Intersection ID: 18066	Main Street: CHARMAPEG_AV	Cross Street: LYTTLETON_DR	Location:	NW
ADA ID: A7252EAD9D56	Ramp Type: PerpDiag	Initial Pass/Fail: Fail	Overall Compliance: No	Severity Score: 37.5

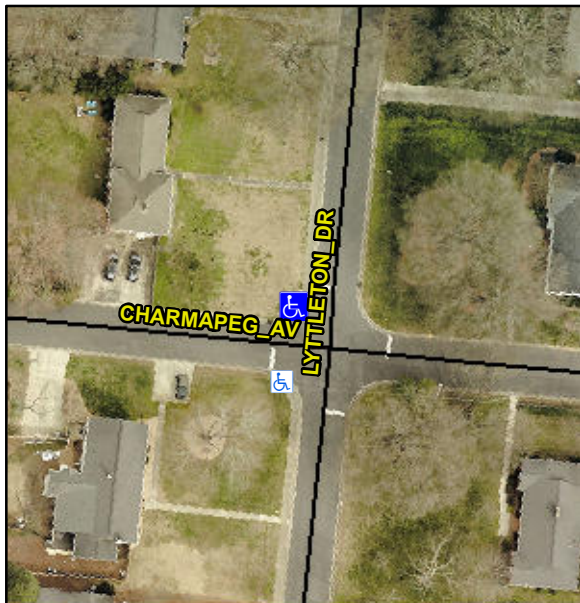
Codes/Mitigation Info/Possible Solution			Field Measurements/Component Compliance								
	Possible Solutions:		Remove & Replace Curb Ramp With Two New Directional Ramps or Equivalent.			Compliance	Description	Data	Compliance	Description	Data
						N/A	Ramp Length (in)	49.0	No	Ramp Slope (%)	9.0
						Yes	Ramp Width (in)	48.0	No	Ramp XSlope (%)	7.6
						N/A	Flare Type LT	N/A	N/A	Flare Type RT	N/A
						N/A	Flare Slope LT (%)	N/A	N/A	Flare Slope RT (%)	N/A
						N/A	Flare Traversable LT?	N/A	N/A	Flare Traversable RT?	N/A
						N/A	Landing Length (in)	N/A	N/A	DWS Provided?	N/A
						N/A	Landing Width (in)	N/A	N/A	DWS Contrast?	N/A
						N/A	Landing Slope (%)	N/A	N/A	DWS Length (in)	N/A
						N/A	Landing X Slope (%)	N/A	N/A	DWS Full Width?	N/A
Surveyor Notes:		N/A			N/A	Landing Curb? (Y/N)	N/A	N/A	DWS Offset (in)	N/A	
PROW/ADA:		Not Found, R304.2.2, R304.5.3			N/A	Shared Landing?	N/A				
					N/A	Gutter Ponding?	N/A	N/A	Gutter Slope (%)	N/A

N/A	Gutter Lip Ht (in)	N/A	N/A	Gutter X Slope (%)	N/A	
					N/A	Painted X Walk1?	No	N/A	Painted X Walk2?	No	
						X Walk 1 Direction	To SW		X Walk 2 Direction	To SE	
					N/A	X Walk 1 Width (in)	N/A	N/A	X Walk 2 Width (in)	N/A	
						X Walk 1 Slope (%)	0.1		X Walk 2 Slope (%)	8.2	
						X Walk 1 X Slope (%)	7.8		X Walk 2 X Slope (%)	2.0	
Street 1 Name		CHARMAPEG AV			N/A	Ramp inside XWalk1?	N/A	N/A	Ramp inside XWalk2?	N/A	
Stop Condition-Street 2		StopSign				Road Slope (%)	5.9	N/A	Clear Space?	N/A	
Street 2 Name		LYTTLETON DR				Road X Slope (%)	7.6	N/A	Clear Space to XWalk (in)	N/A	
Stop Condition-Street 1		StopSign			N/A	Any Obstructions?	N/A	N/A	Storm Grate/Utility Hazard?	N/A	
						Obstruction Type			Storm Grate/Utility Type		
							N/A			N/A	
								Yes	Surface Condition? (G/P)	Good	
Total Cost:		\$ 3200.00
